**STAFF REPORT
PLANNING MANAGER DECISION**

FILE NO.: DR-22-07

REQUEST: Approval of a Class I Historic Design Review and Class I Design Review at 4835 Willamette Falls Drive

1 Partial Site Plan - New Work
 1/8" = 1'-0"

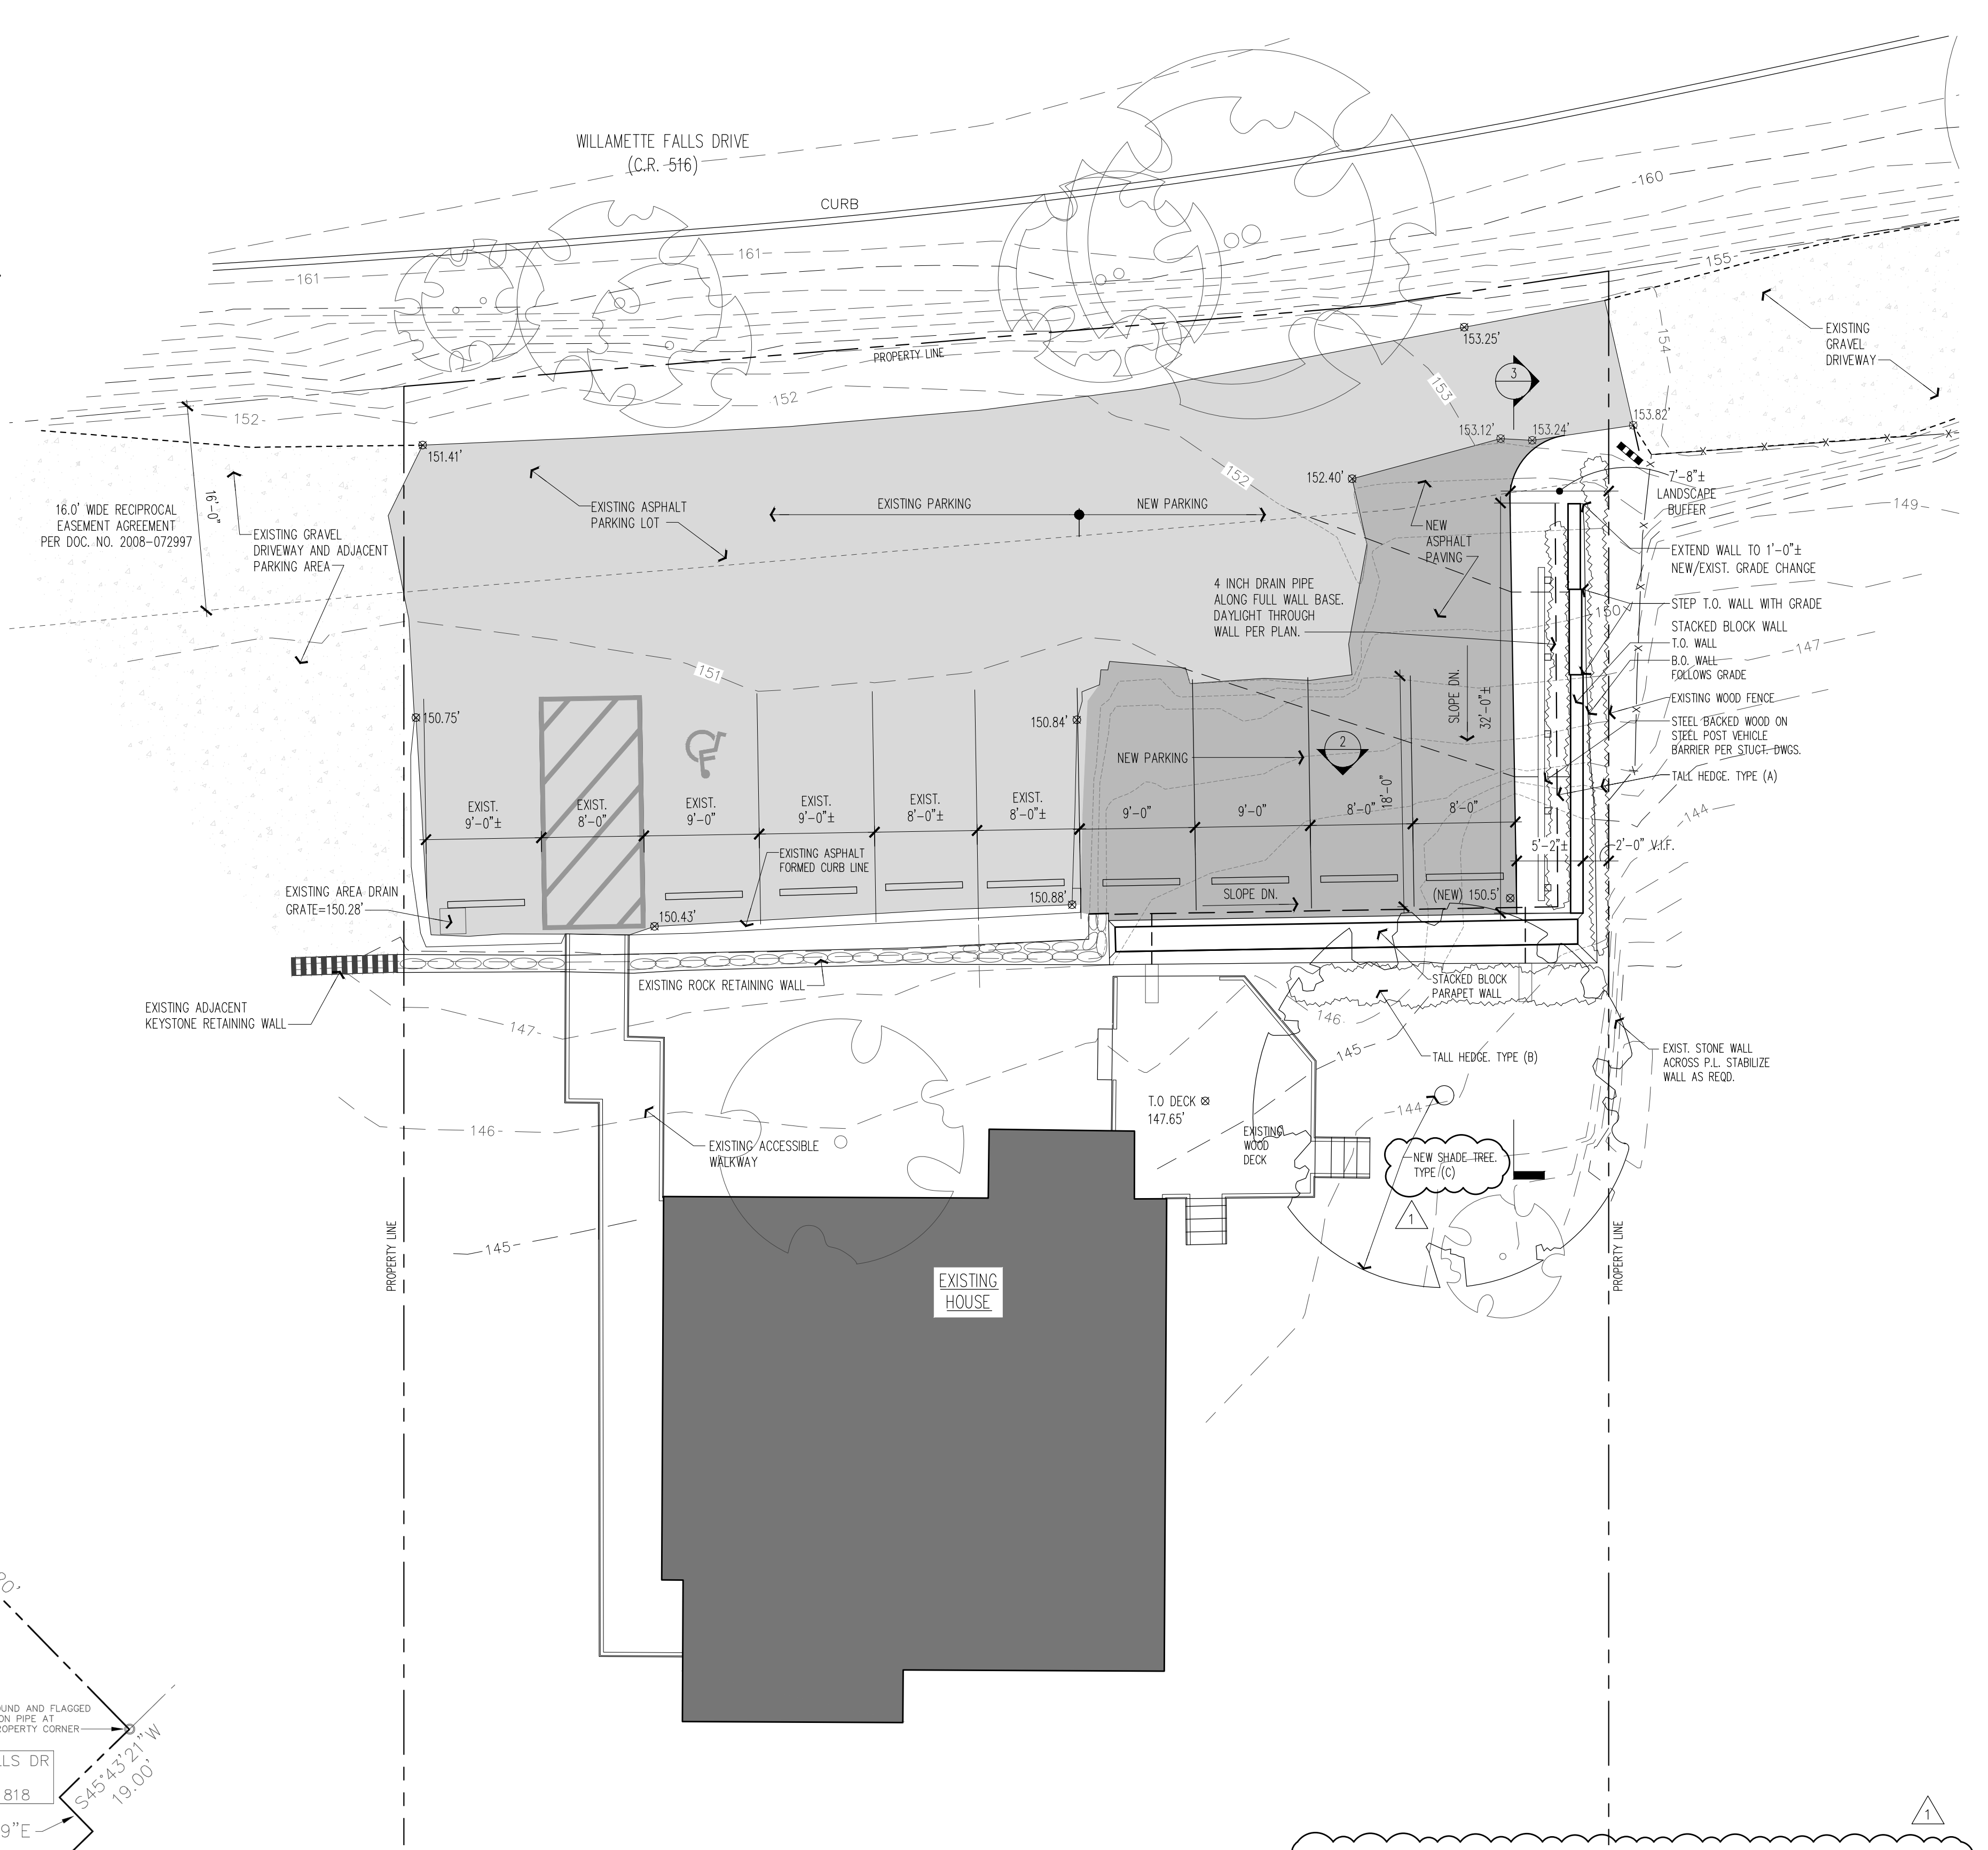
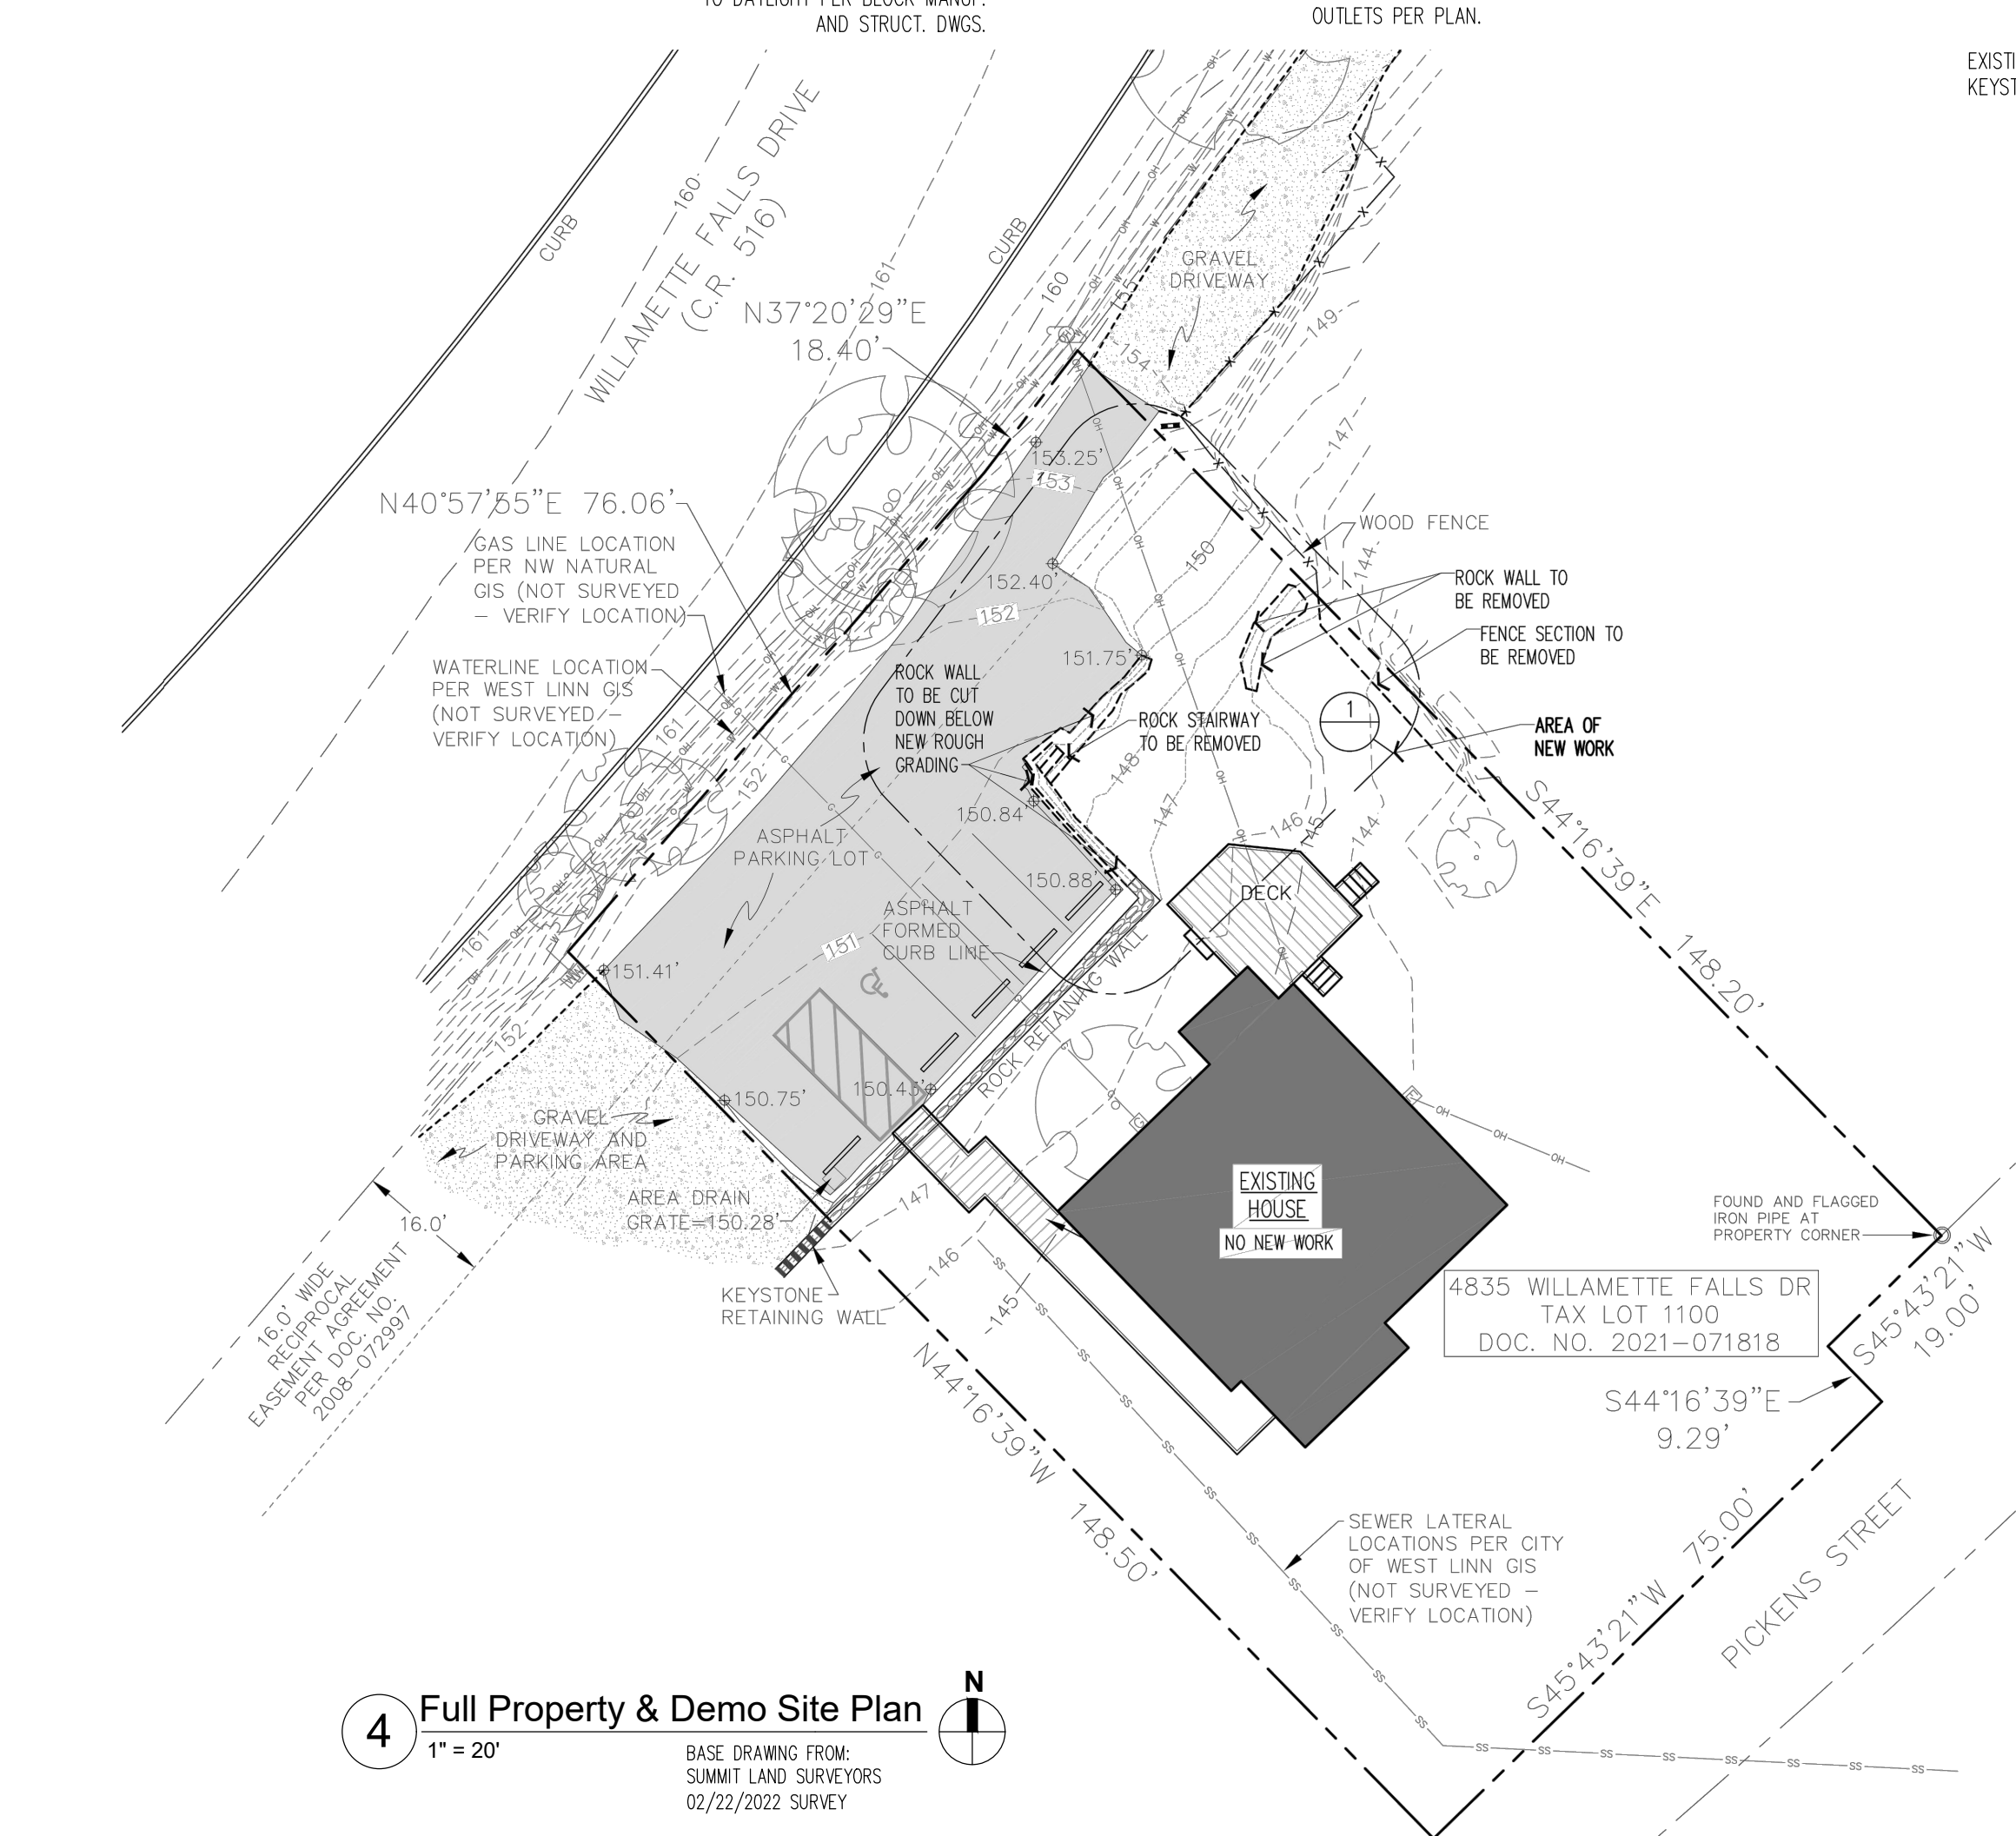
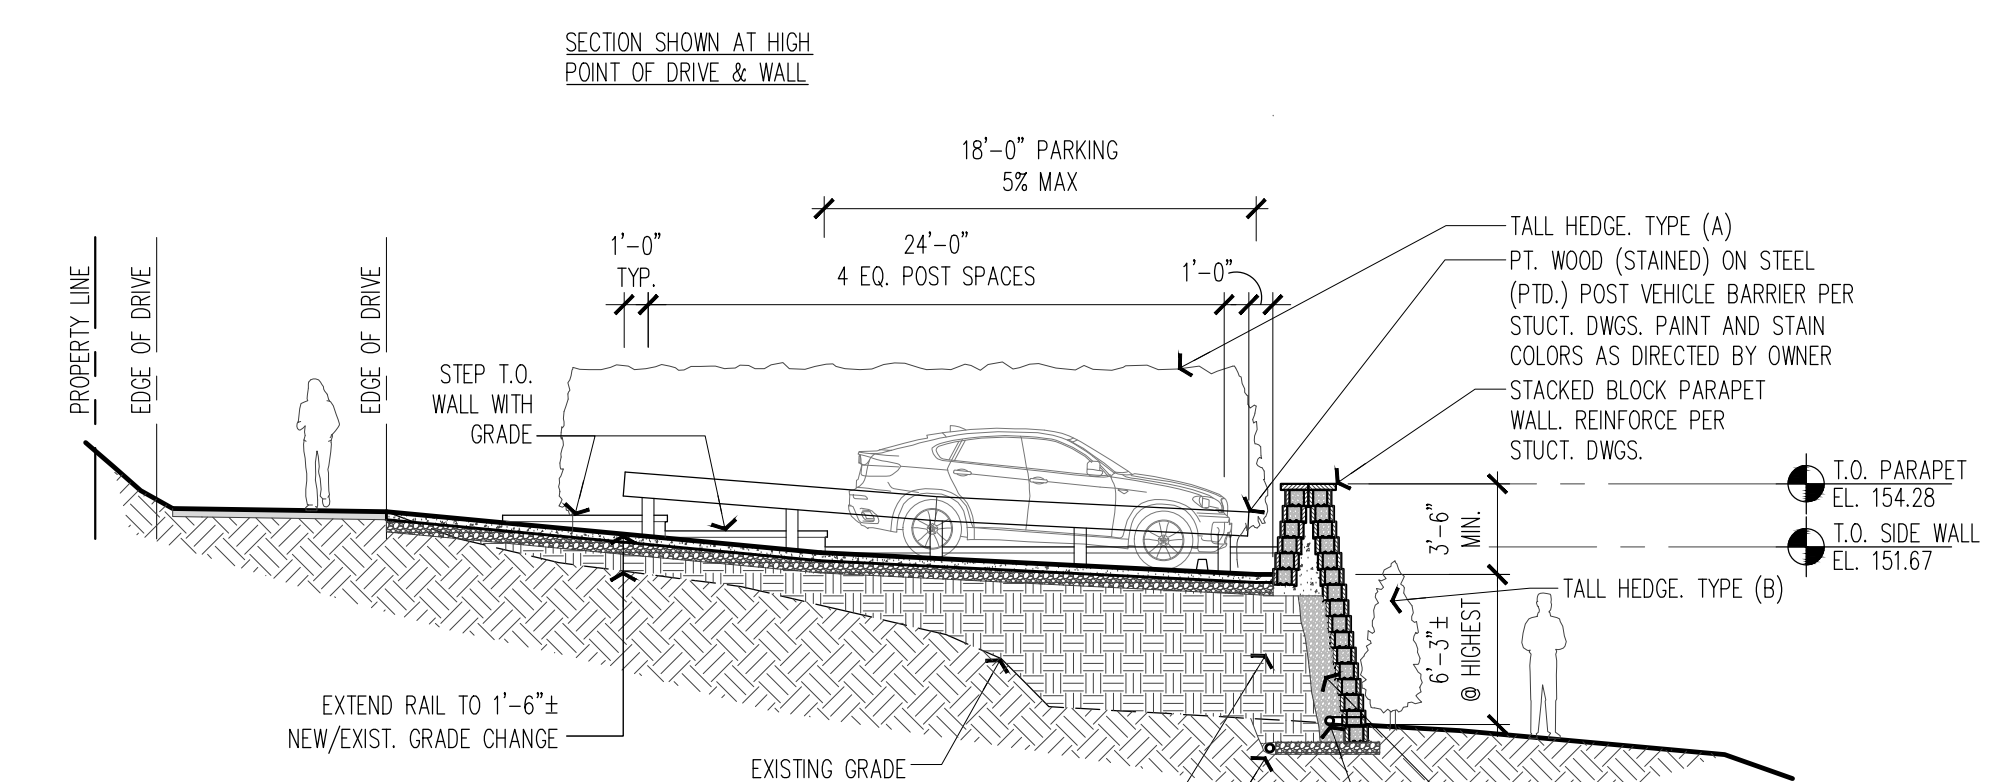
Staff Finding 7: The application includes a site plan demonstrating the proposed parking layout (Sheet HR-1 of Exhibit PD-1). Of the four new spaces, two will be 8 feet x 18 feet and the other two will measure 9 feet by 18 feet, in compliance with minimum dimensional standards. Five of the nine spaces will be standard spaces and four compact spaces, in compliance with the requirement that no more than 50% of the spaces be compact. All spaces are proposed on asphalt with striping and wheels stops demarcating the boundaries of the space, and continue a head-in parking configuration previously approved by the Planning Commission in DR-09-01. Striping will be confirmed during final planning inspection as part of the normal building permit process. Vehicular and pedestrian access to the property is per a nonconforming 16' wide reciprocal access agreement, also approved by the Planning Commission in DR-09-01, subject to a trip cap limitation (Exhibit PD-4). Neither the access nor the trip cap is proposed for modification, and the increase in parking spaces will not result in additional trips to the site above existing conditions. These standards are met.

Staff Finding 18: These standards are applicable as they are referenced in the parking area standards discussed in Staff Finding 12. Per these standards, buffering is required between different types of land uses, such as the proposed parking area and the adjoining property containing a single family dwelling. The applicant has proposed a planting plan on sheet HR-1 that includes a 7-foot wide area planted with hedges to provide a buffer between the last parking stall and the adjoining property line. The eastern side will be planted with a row of arborvitae at the top and bottom of the eastern retaining wall. Similarly, the plan shows a

hedge of rhododendron along the southern side of the retaining wall. Combined with the parapet wall, these will provide year-round screening of the new retaining wall and parking area from the adjoining residential property. Installation of all landscaping will be inspected and confirmed during the building permit process. These standards are met.

Staff Finding 19: No residential uses are proposed on site. The only source of light and glare would occur from the new parking spaces, which will be screened by the proposed vegetation addressed in Staff Finding 18 and sheet HR-1. The existing law practice within the structure is not reasonably expected to generate noise in excess of the city's noise standards. Therefore, these standards are met or do not apply.
